August 6, 2015

RE: Sharon W.S.C.  
Application to Amend Water CCN (10476)  
PWS ID# 2500020  
Upshur County, Texas

*SHARON W.S.C.*  
**CCN AMENDMENT APPLICATION**  
**WOOD COUNTY, TEXAS**

I. Ability to Provide Adequate Service.

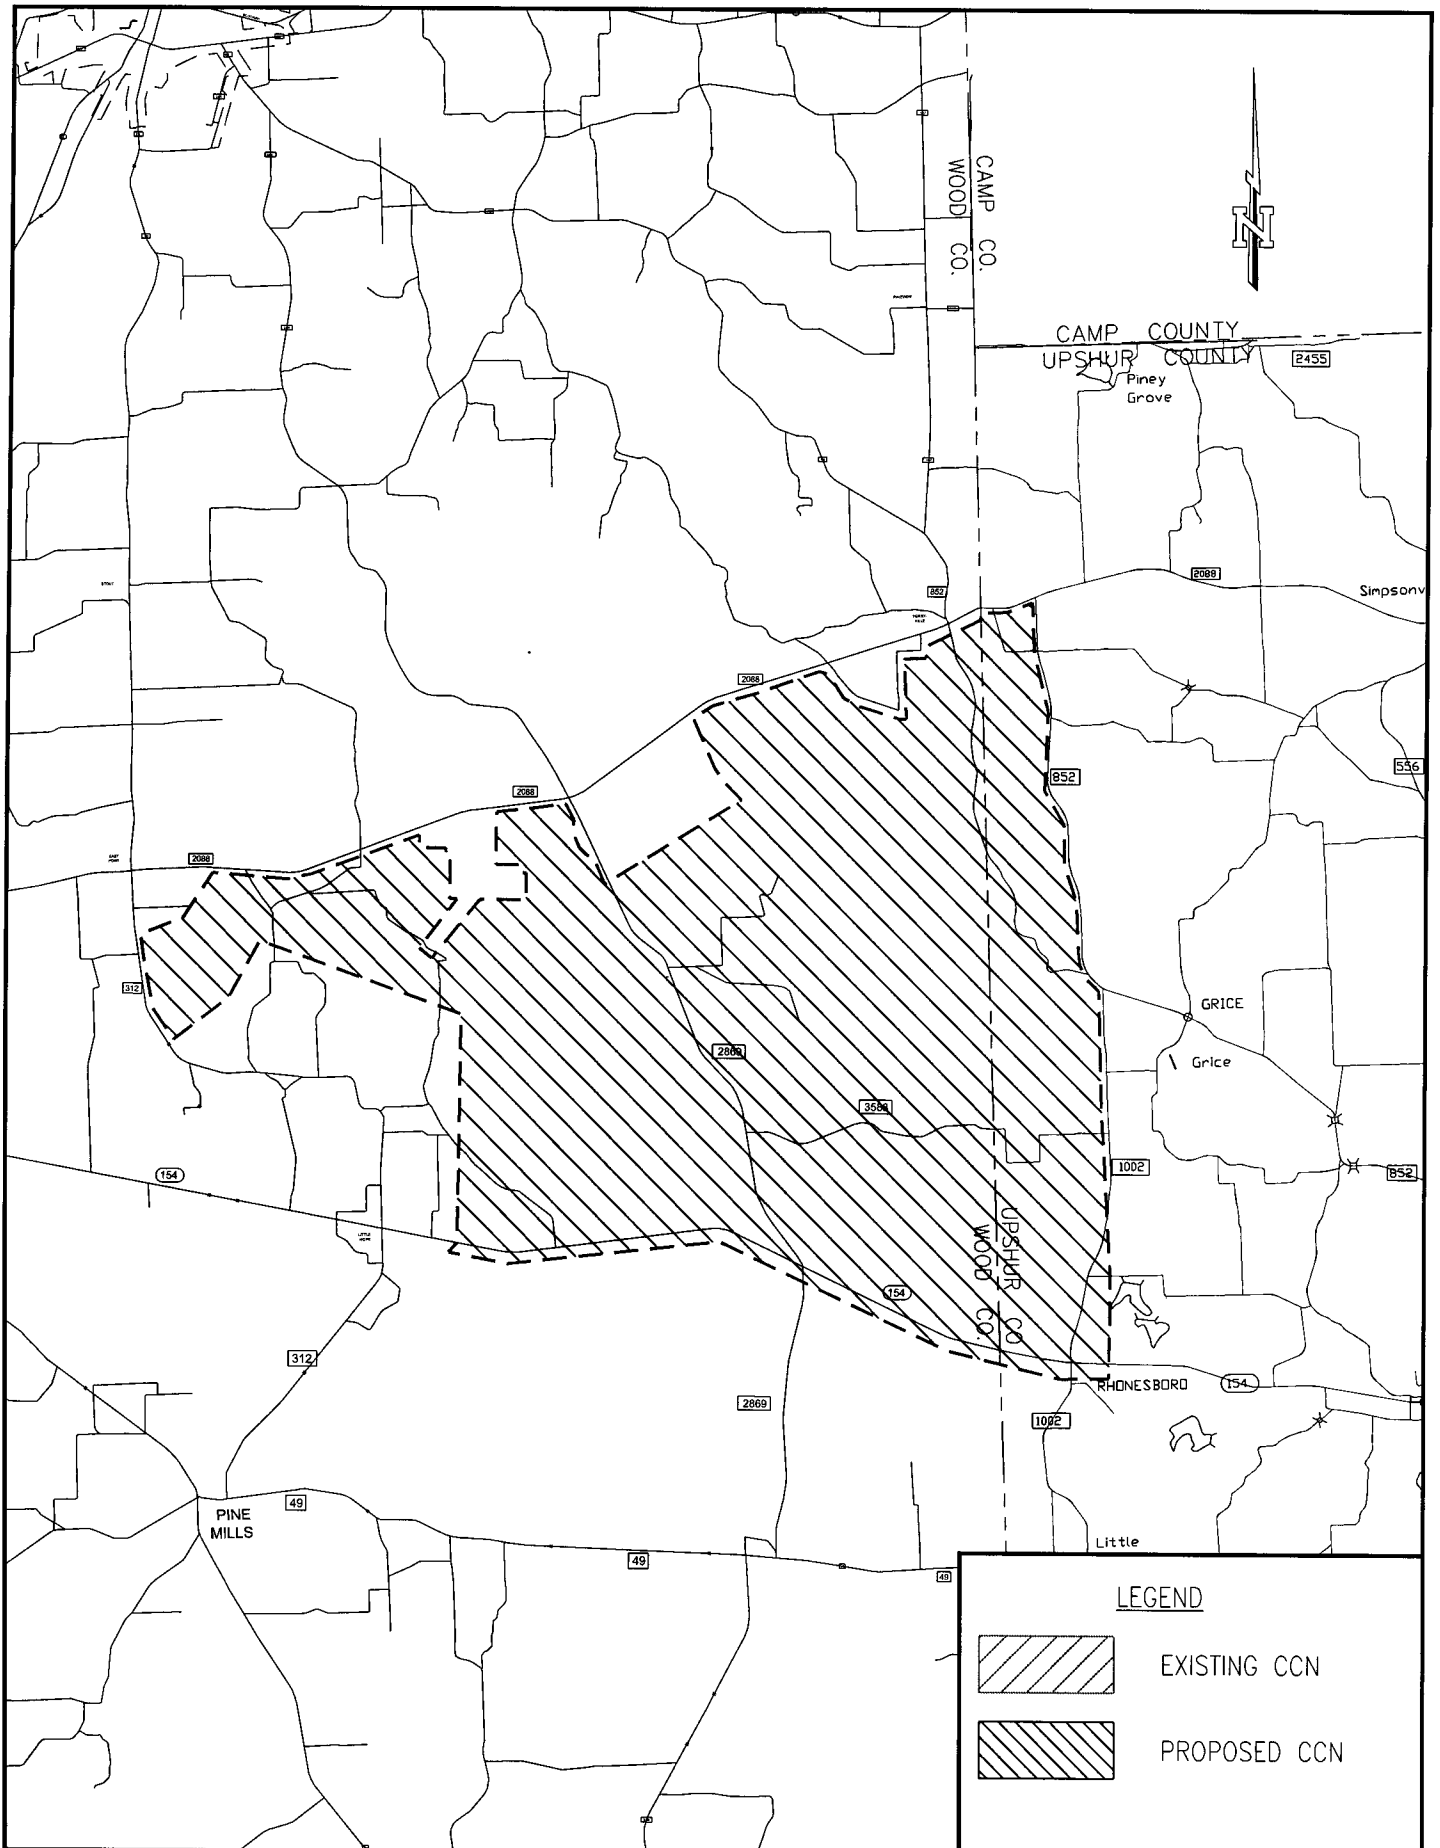
4. Response to question J on page 9 of the application. **See attached for revised page.**
5. Requests for service from landowners or developers in the proposed area to demonstrate a need for service. **See attached for a list of property owners who have formally requested service from Sharon WSC in the past. In addition to these property owners, approximately 30 additional owners have informally inquired about service in the area over the last two years.**

J. Effect on the Land. Explain the effect on the land to be included in the certificated area.

PROPOSED SERVICE AREA WILL PROVIDE WATER TO THE EXISTING RESIDENTS INSIDE PROPOSED SERVICE AREA, THERE WILL BE NO EFFECT ON THE LAND.
